**Project #23-011
Jack in the Box
Located at ~1200 South HWY 89/91**

Project Name: Jack in the Box
Proponent/Owner: Sherri Miller / Highway 89 Plaza, LLC
Project Address: ~1200 South HWY 89/91
Request: Design Review Permit
Current Zoning: Commercial (COM)
Date of Hearing: January 26th, 2023
Type of Action: Quasi-Judicial
Submitted By: Russ Holley, Senior Planner

RECOMMENDATION

Staff recommends that the Planning Commission **approve** a Design Review Permit for Project #23-011 Jack in the Box for a 2,341 SF commercial restaurant building located at approximately 1200 South Highway 89/91: TIN #02-087-0002.

SITE PLAN
 (H)
SD1.0

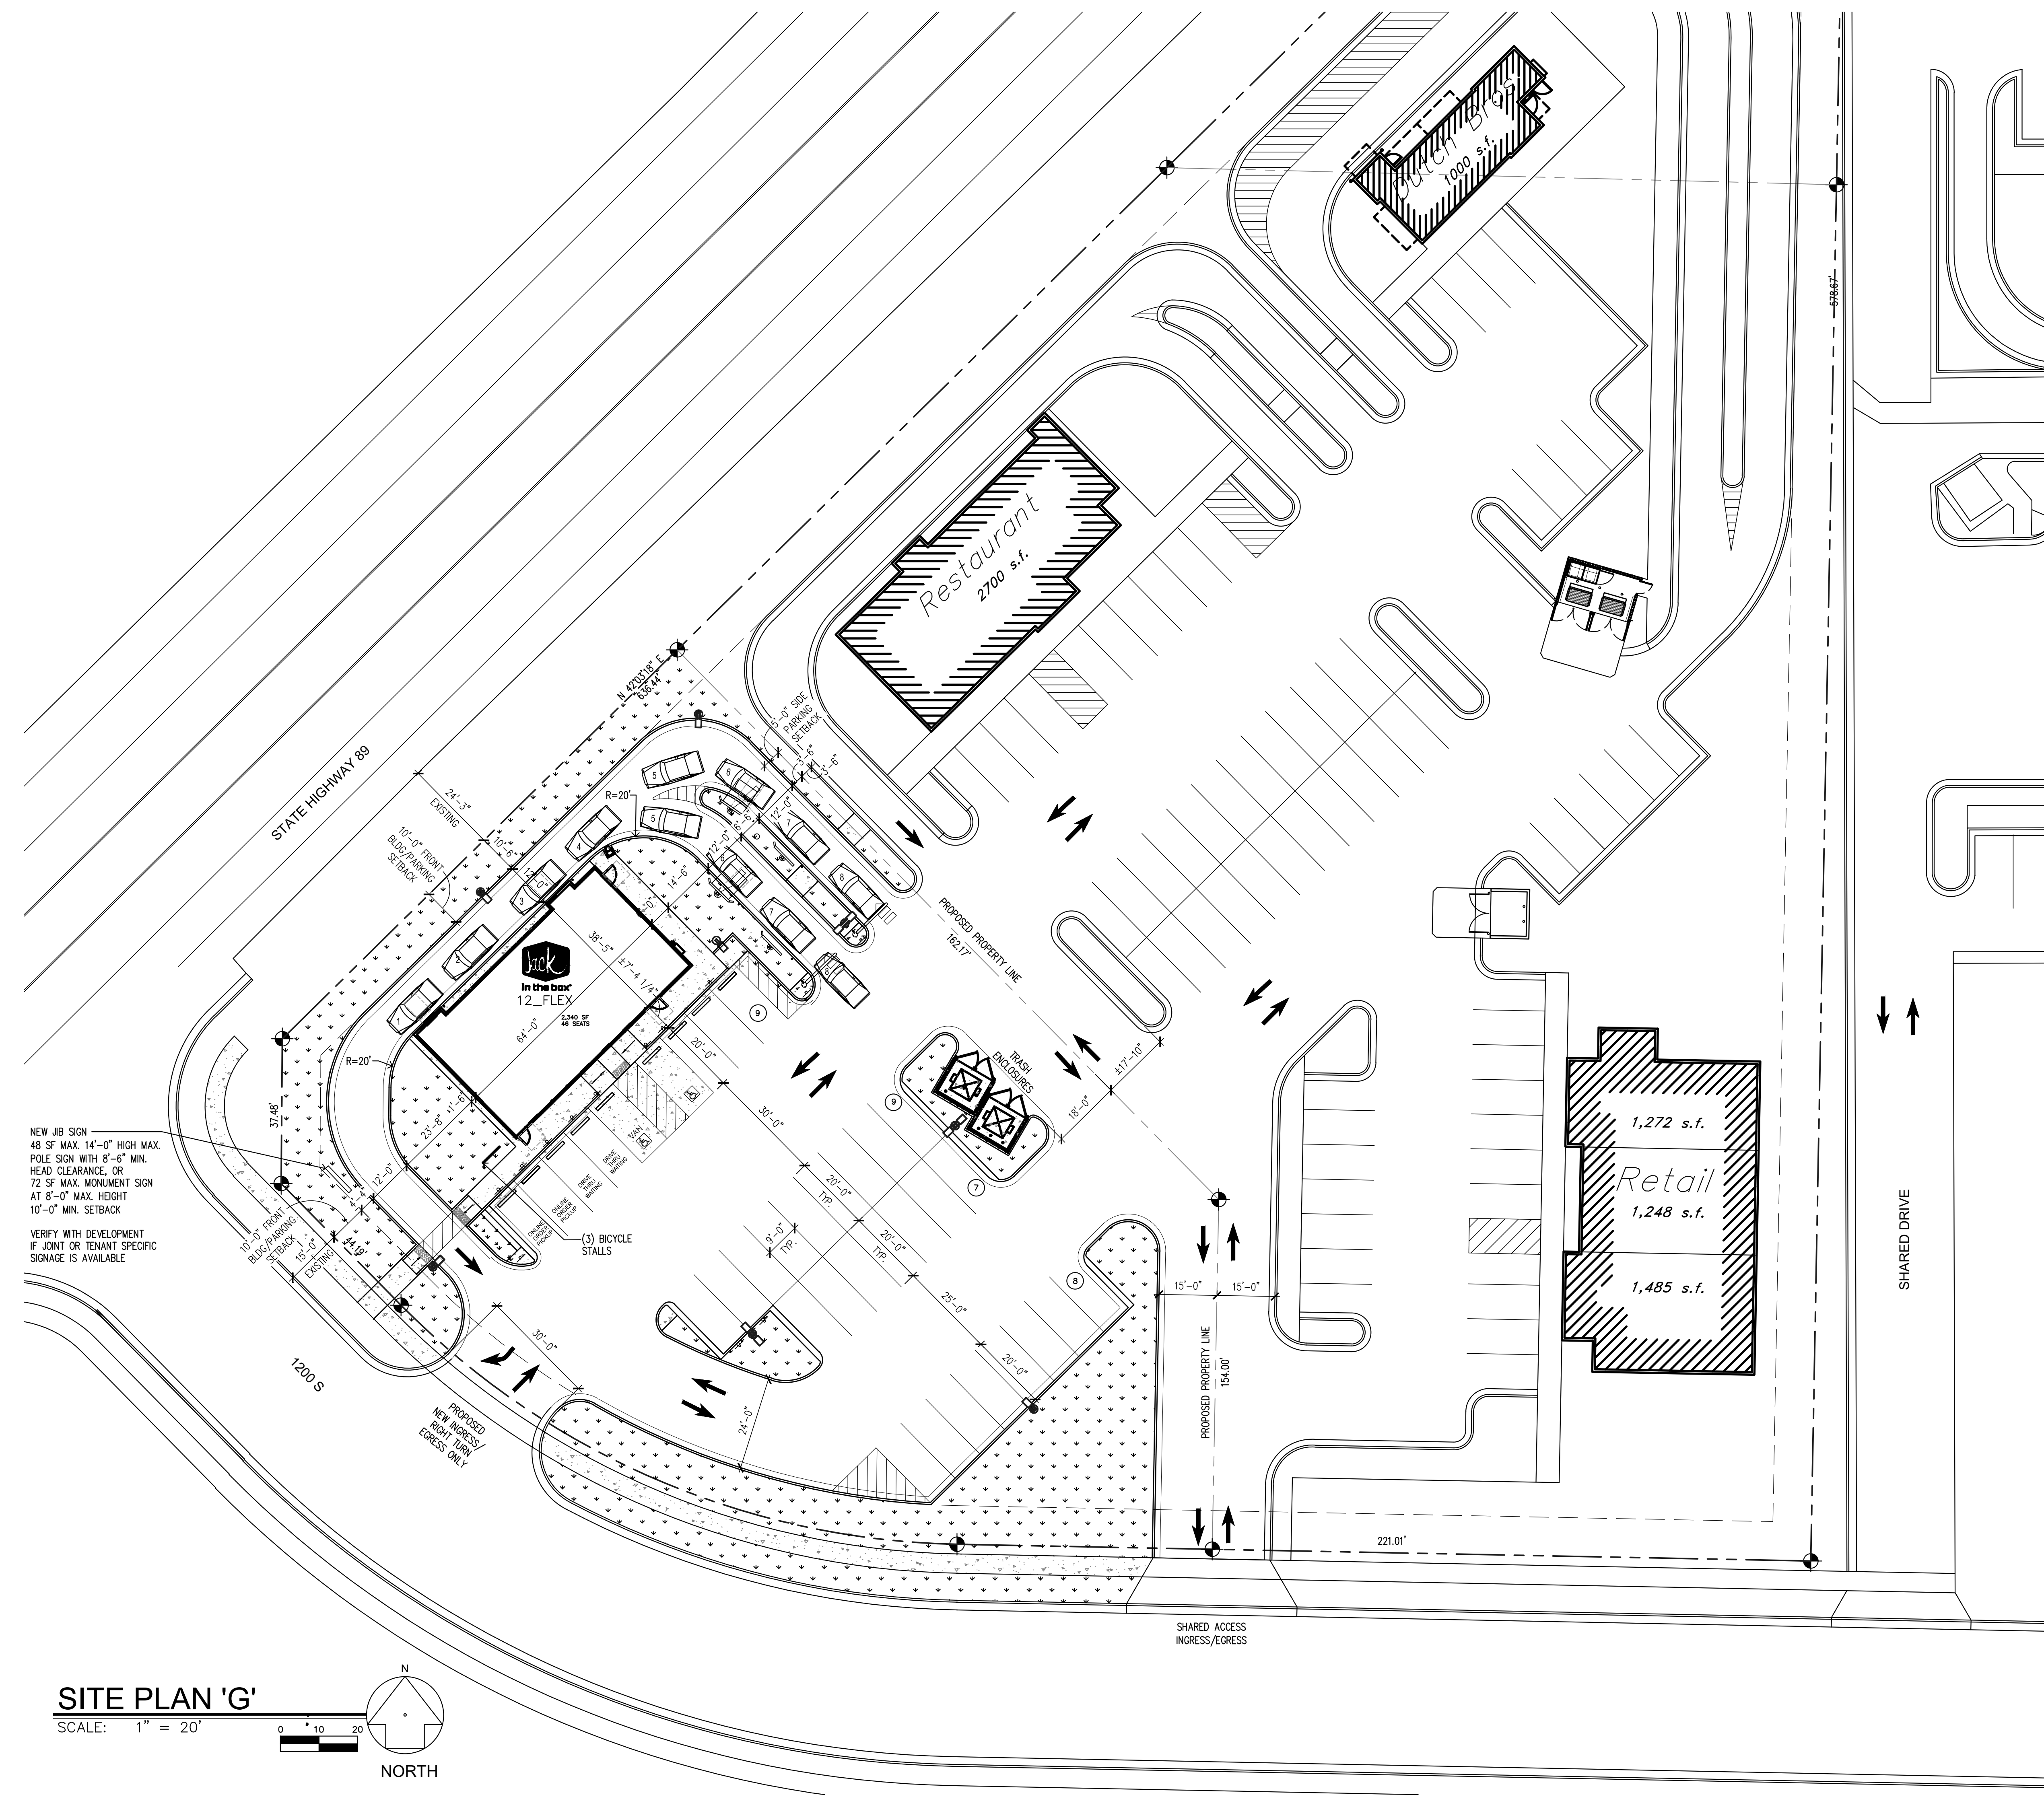
The LDC 17.10.030 requires safe and convenient pedestrian circulation that results in sidewalks connecting streets to building entrances. The site layout shows a sidewalk connection from 1200 South to the east entrance of the building. As the development continues to the northeast, the sidewalk should extend to other businesses for overall pedestrian circulation. As conditioned with the sidewalk continuing to the northeast edge of this project site boundary, the project meets the requirements in the LDC.

The LDC 17.31.040 requires one parking stall per every 150 SF of fast-food restaurant square footage. At 2,341 SF, this building would require 16 parking stalls. The proposed site plan contains 33 parking stalls. Restaurants require bike racks as per LDC 17.31.040 and the submittal shows a bike rack near the entrance of the building. As submitted, the project meets the parking requirements in the LDC.

5. The project shall provide at least 16 parking stalls and a bike rack.
6. Open space and landscaping shall comply with LDC standards and detailed landscaping plans shall be submitted and approved prior to a building permit issuance. Street tree shall be planted along street frontages at 30 foot spacing.

7. The sidewalk connecting the building to 1200 south shall be extended to the project boundary in a functional alignment for pedestrian access to future retail/restaurant buildings to the north.

EXTERIOR ELEVATIONS
FLEX
A4.1

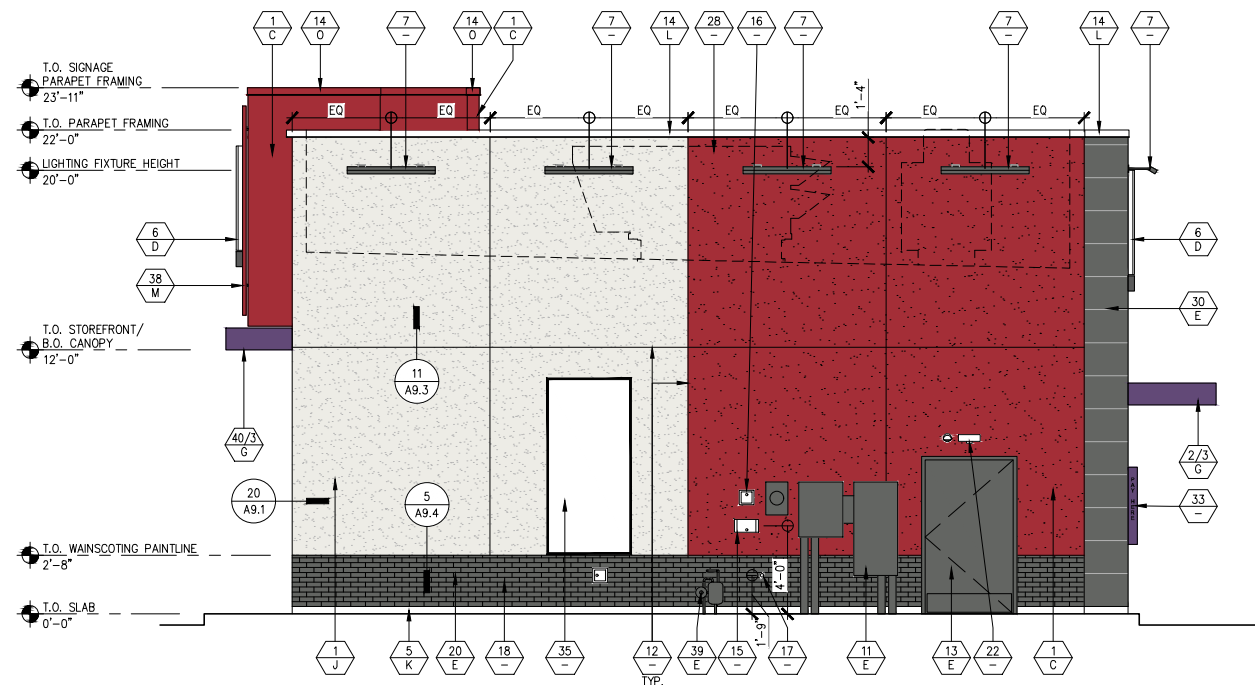
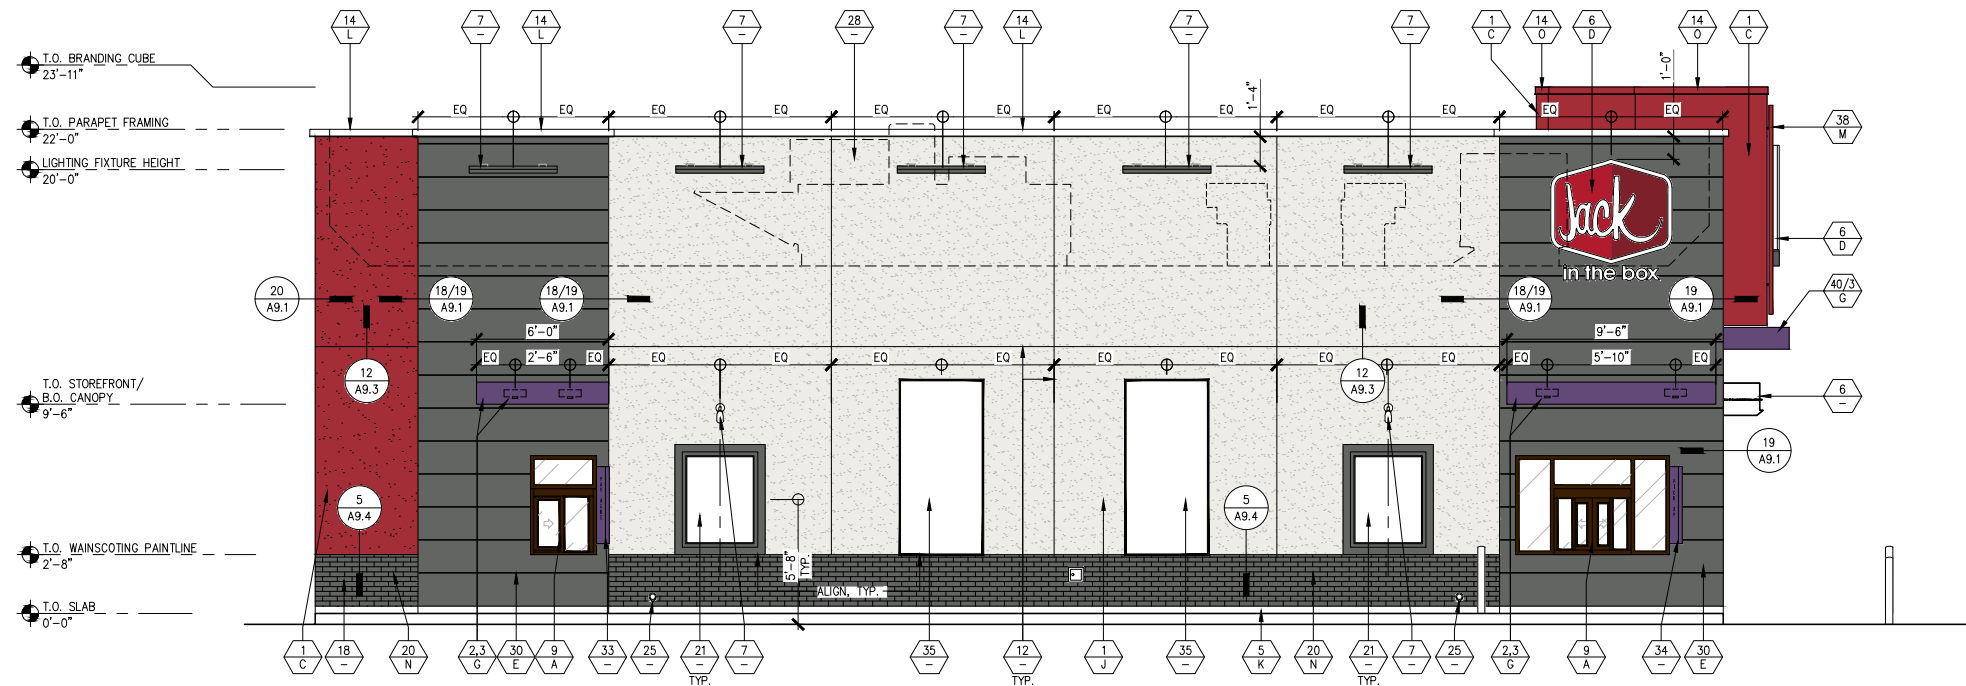
The LDC 17.12.020 requires four-sided architecture with all sides of the building receiving equal architectural design consideration. Blank or featureless walls in the COM zone are limited to no more than 40-foot lengths. Generally, no building shall have blank walls unless the decision-making body determines the impacts are minimal. Ground floor street facing facades shall have a minimum of 30% transparency (fenestration). The proposed building shows a variety of shapes, materials and finishes that comply with blank wall requirements but the proposal shows less than the 30% transparency on the west and south facades. The west façade shows two drive-thru windows totaling approximately 5% transparency and the south façade show windows near the east side totally approximately 20%. Most of the transparency is located on the east façade adjacent to the parking lot and contains approximately 40% on that side of the building. As conditioned with additional transparency on the west and south side, the building design meets LDC standards.

3. The west and south facades shall have 30% transparency. The Planning Commission may approve spandrel windows or landscape trellising that can count towards this minimum requirement.
